Millstone Nuclear Power Station, Unit 3
NRC Chemical Engineering Branch (Fire Protection)
Review Meeting, March 28, 1984

Status of the NRC-CMEB (Fire Protection)
Draft SER Open Items Discussed at the Meeting
with the NRC-CMEB March 28, 1984

Responses to the Draft SER Open Items

SKETCH FP4-1

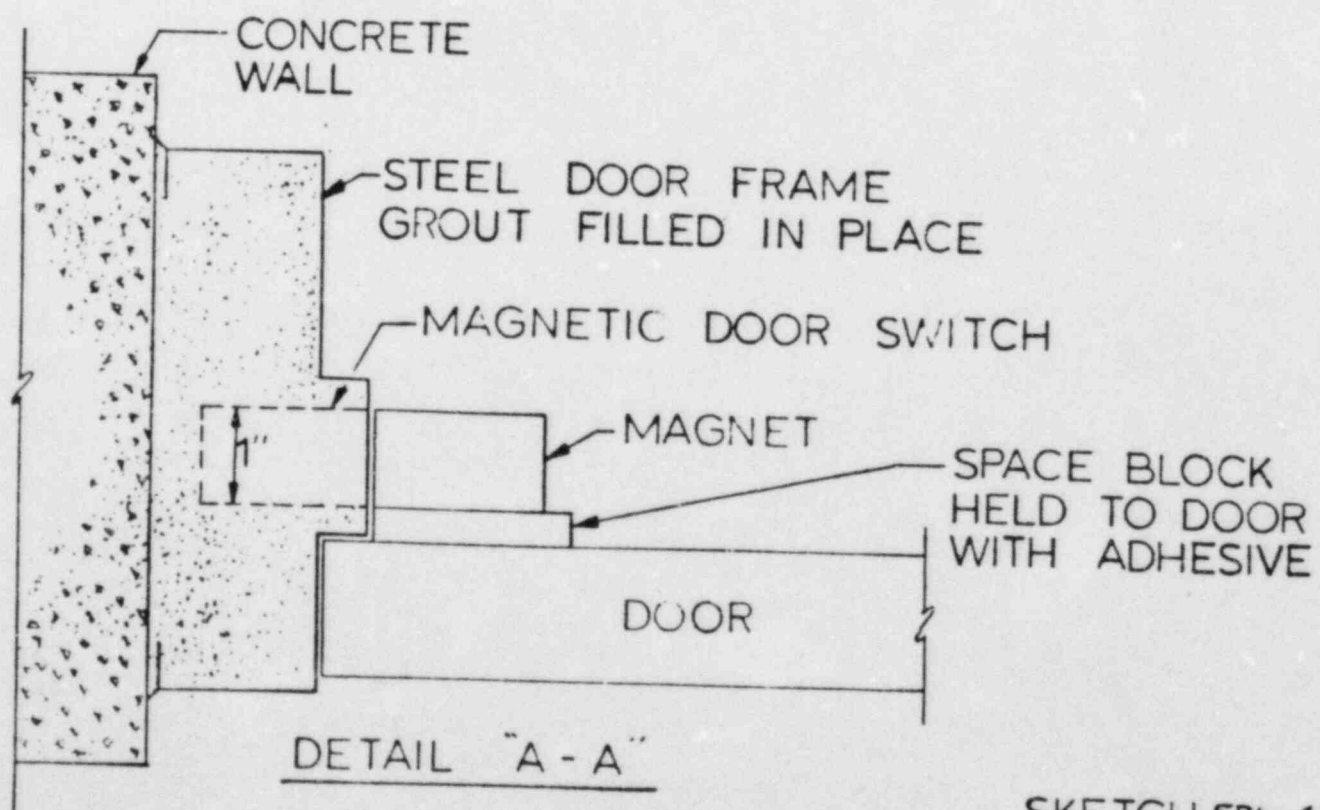
We will require that all fire door assemblies installed in the plant have been tested and labeled in accordance with NFPA 252 "Fire Tests of Door Assemblies." This is an open item.

- a) As shown on attached sketch FP4-1, the door frames have been drilled to:
 - o accommodate the installation of magnetic door switches and electrical conduits.
 - o simplify the grouting of the door frames to the surrounding concrete wall.

It is NNECO's position that the type of security modifications being done to labeled fire doors will not affect fire doors structural stability or ability to prevent the spread of fire based upon the fact that the door frames are grouted in-place. The normal procedure for the installation of the door frame requires that it be securely anchored to the surrounding wall in a specified number of places. During the design phase of Millstone Unit No. 3, it was decided to construct all door openings a quarter inch larger than necessary to simplify their installation. Thus following installation of the door frames, a space will exist between it and the wall. In order to fill this void space, each door frame is being filled with a cement grout as illustrated in sketch FP4-1. This will involve filling the entire door frame and void space such that it will become a structural part of the surrounding wall. Thus, the modifications made will not cause the door frames to violate their original acceptance criteria from NFPA-252 which states that:

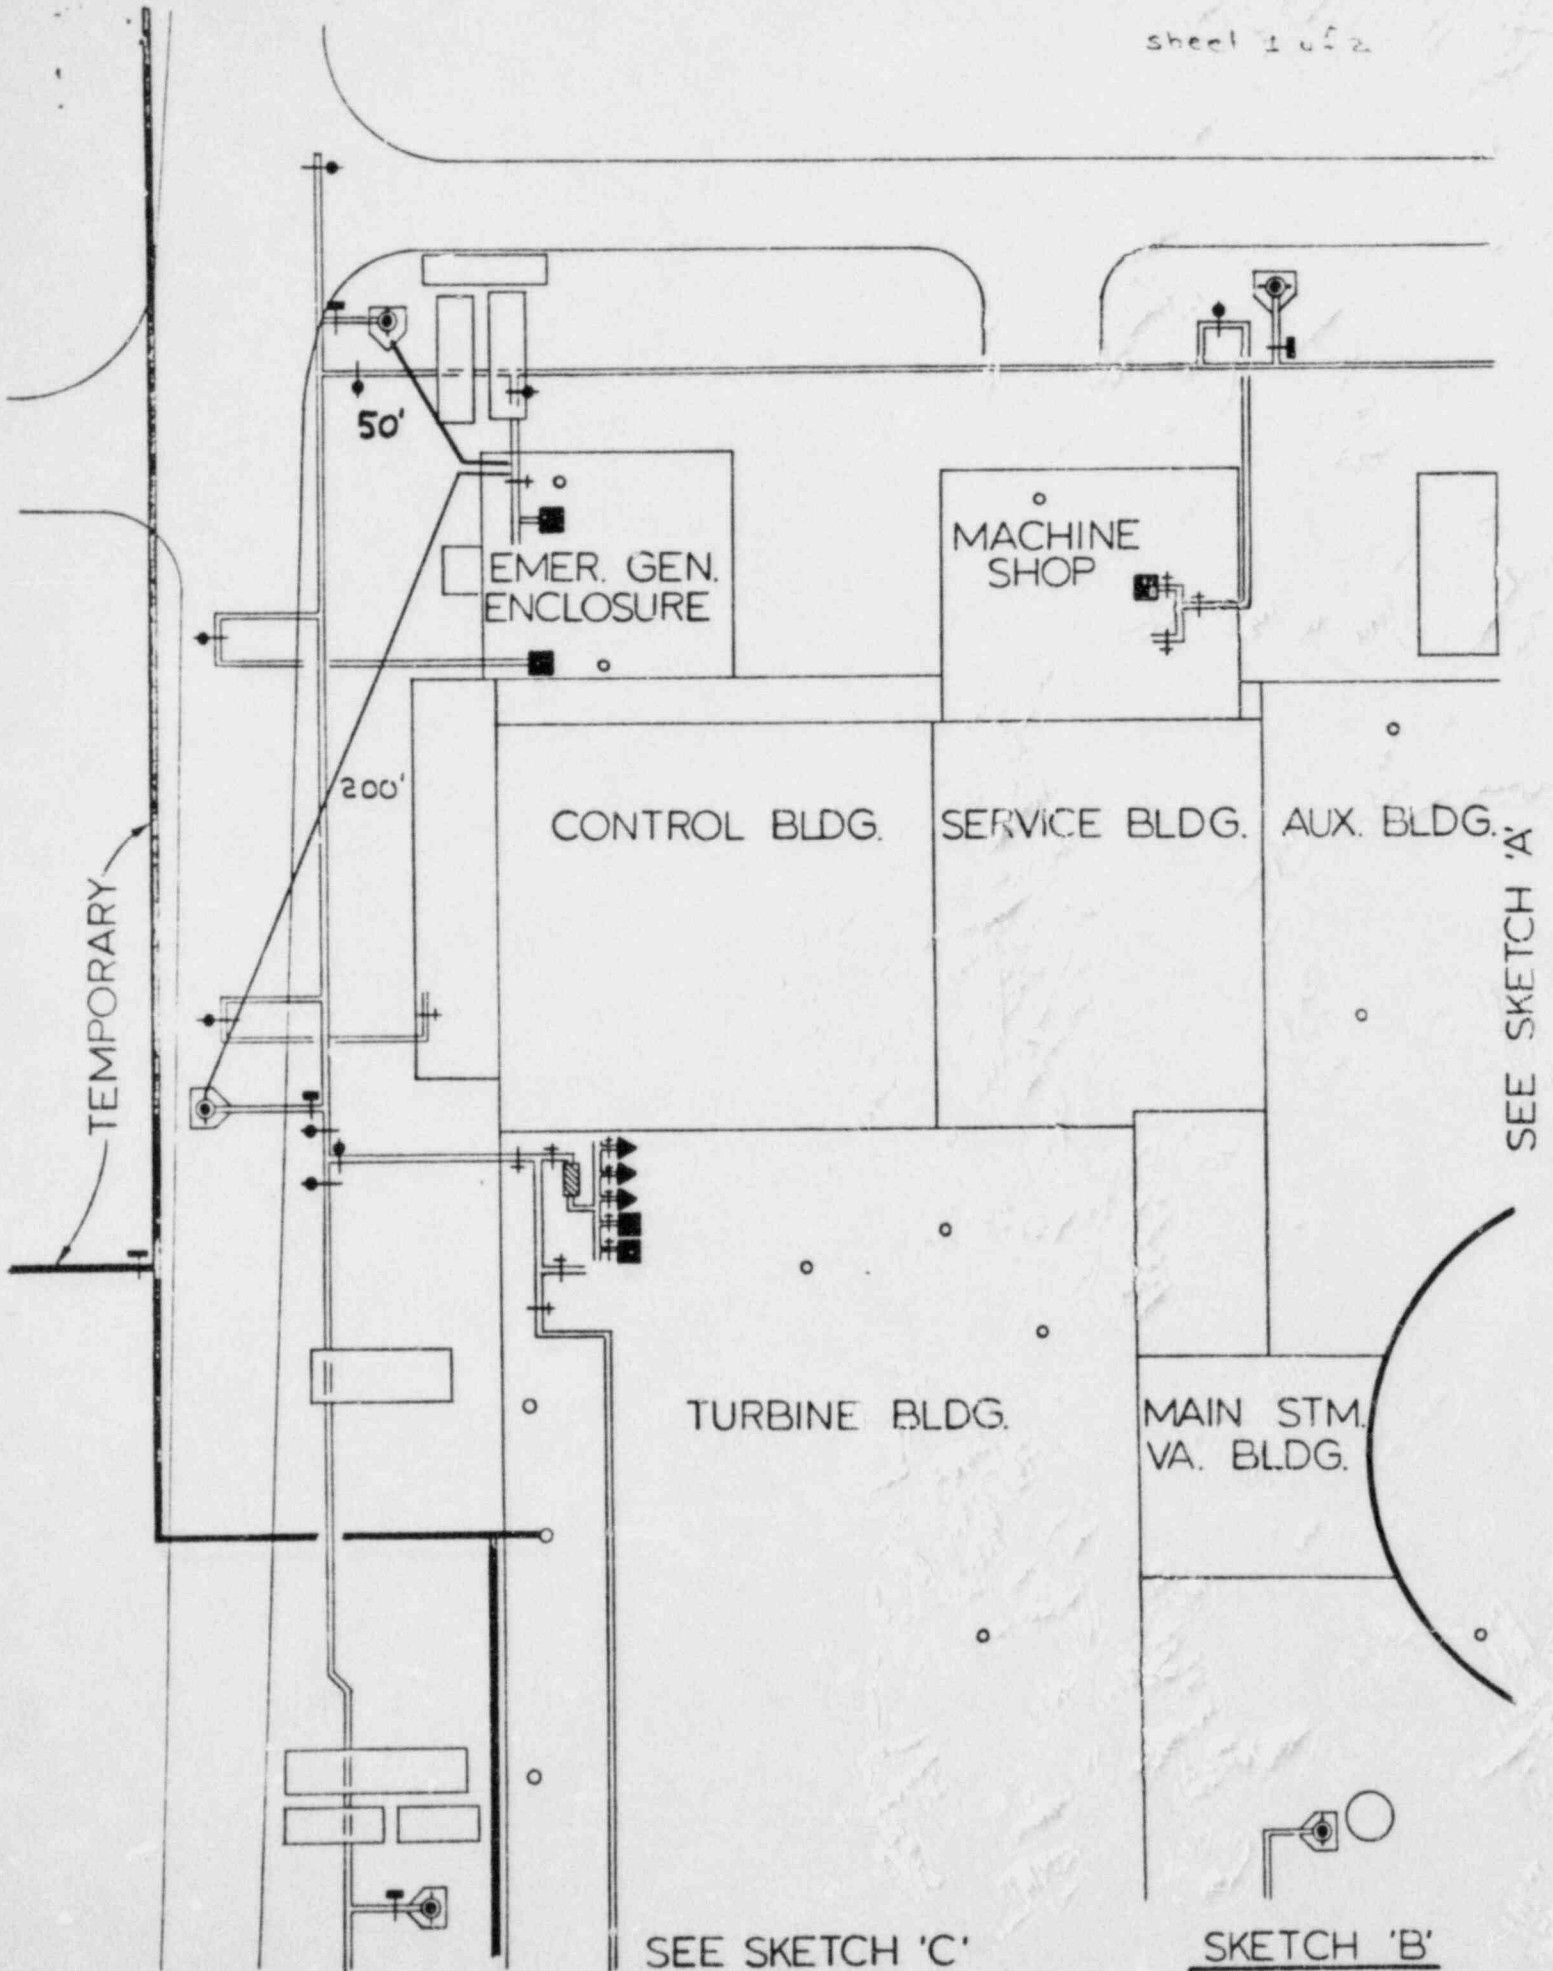
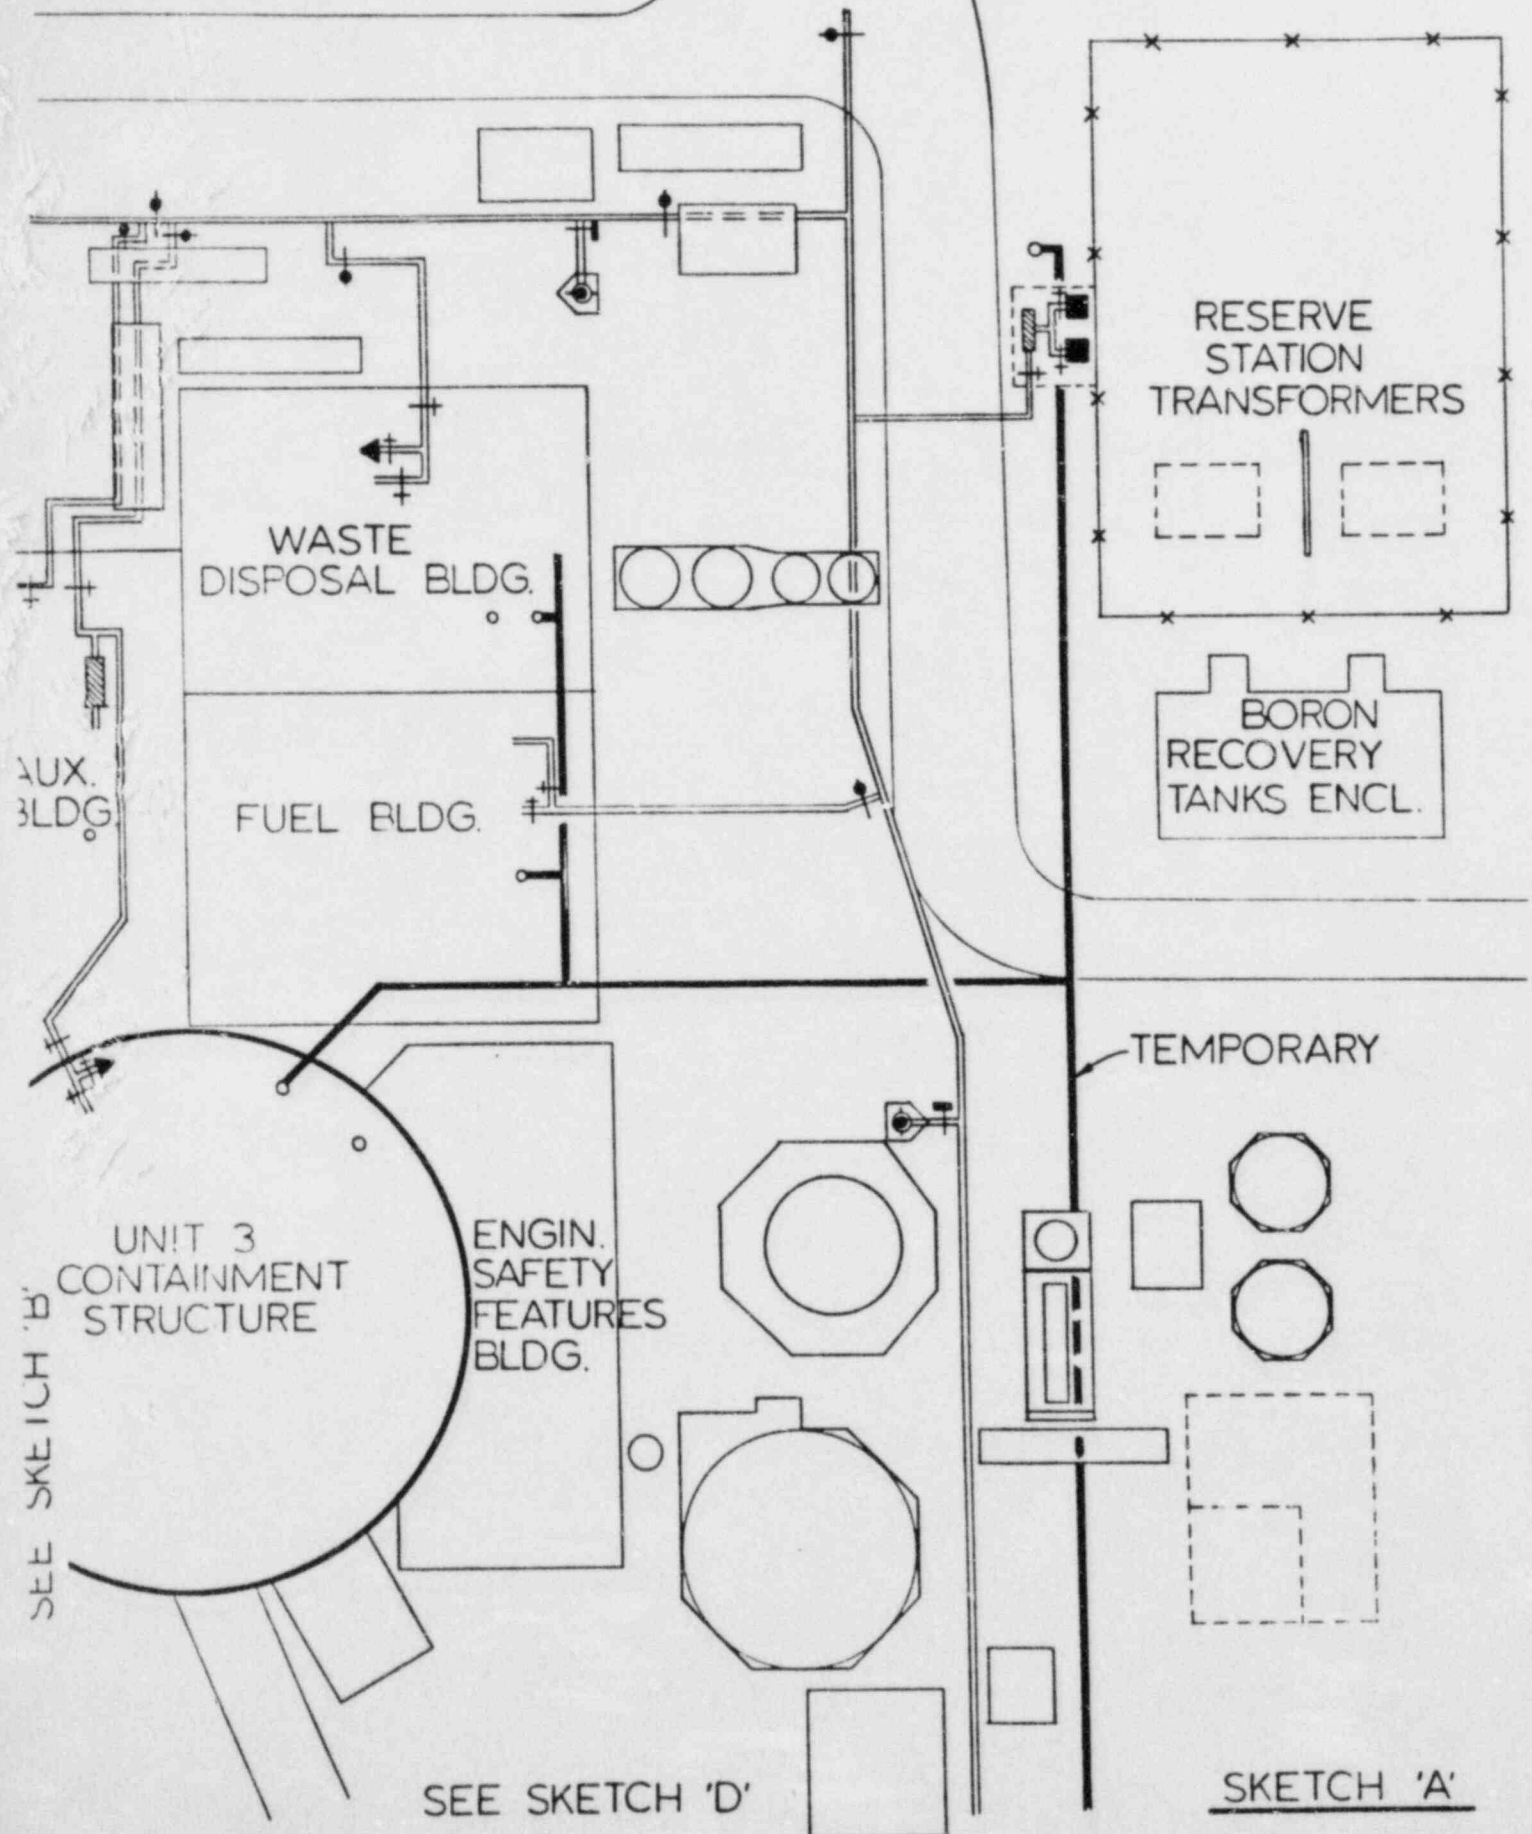
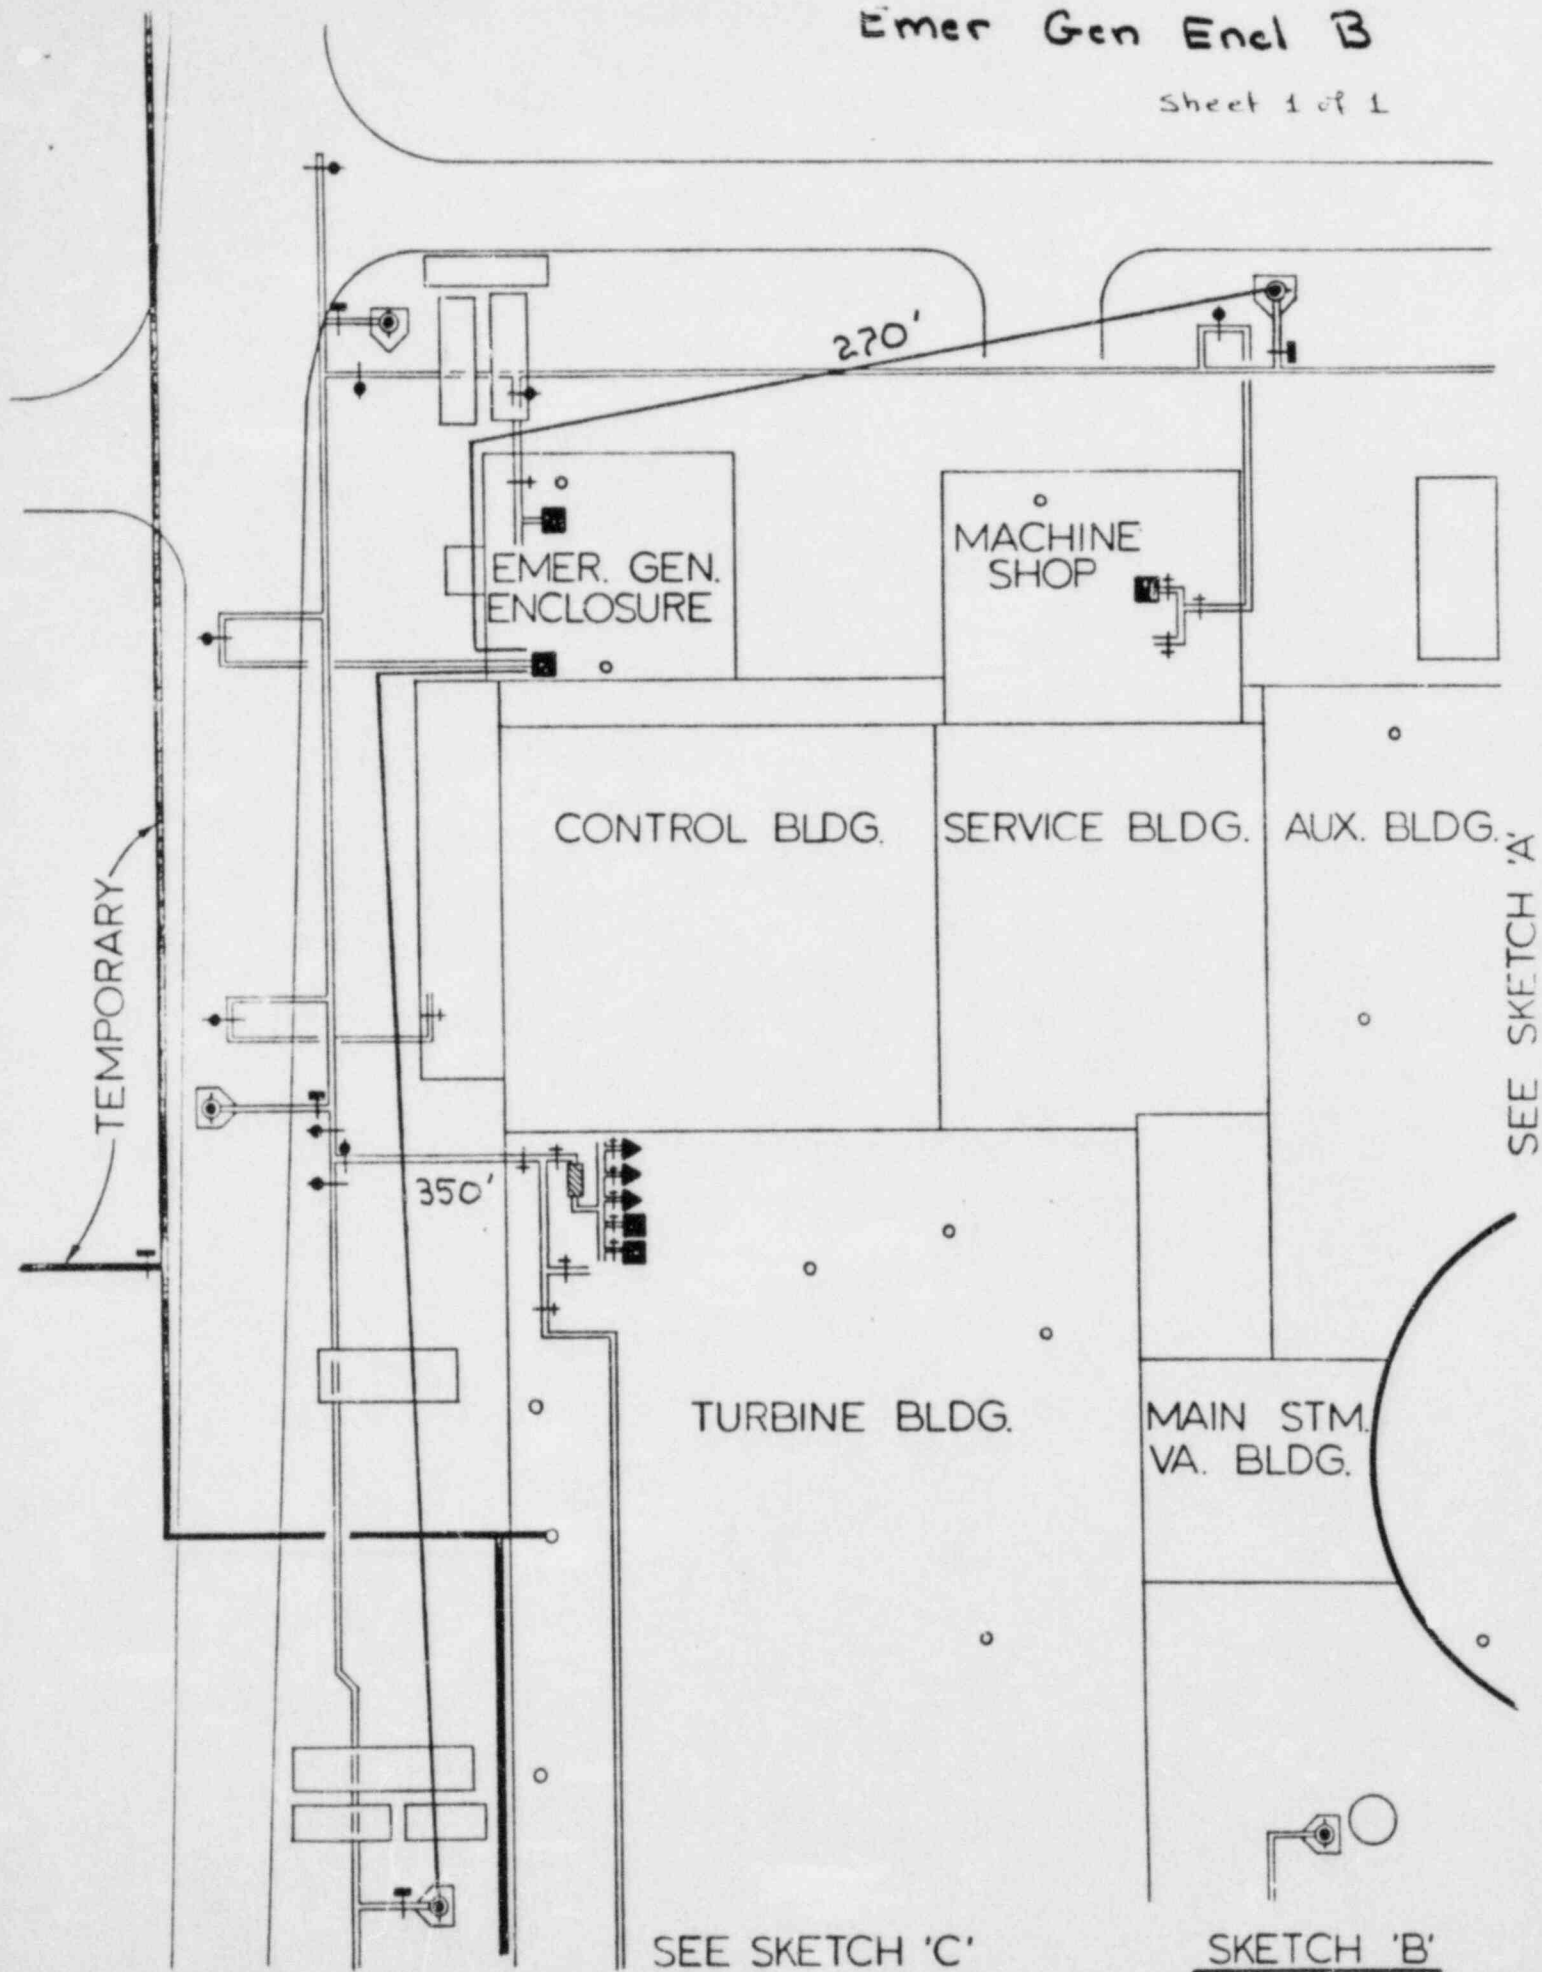
We will require the applicant to provide a fire protection water supply for the emergency generator enclosure, service building, waste disposal building, containment and the auxiliary boiler room such that a single break or failure in the supply piping will not result in the loss of both the primary and secondary water supplies. This is an open item.

The design of the underground fire water supply system at Millstone Unit No. 3, as illustrated on attached sketches A through D, is such that a minimum number of fire water suppression systems would be affected by a single break or failure. This same philosophy has also been utilized in the design of the plants interior fire water suppression systems. It is NNECO's concept should a break or failure occur in the fire water supply piping at Millstone Unit No. 3 to either:

- o Temporarily supply those fire water suppression systems rendered inoperable utilizing large diameter fire hose (2½ inch). Fire hose of sufficient quantity and size would be utilized to adequately supply the inoperable systems. These fire hoses would be supplied from fire hydrants connected to the underground fire water supply system that are unaffected by the break and/or failure. (See Table FP14-1).
- o Provide adequate manual fire suppression capability, in those areas affected by the pipe/break failure, by routing fire hoses from adjacent operable portions of the fire water system.

1. Those portions of the fire water supply piping highlighted in yellow are considered inoperable based upon a pipe break.
2. The primary temporary supply is the shortest route/discharge to an operable yard hydrant/water source.
3. The secondary temporary supply is the alternate source to the primary should it be unavailable.
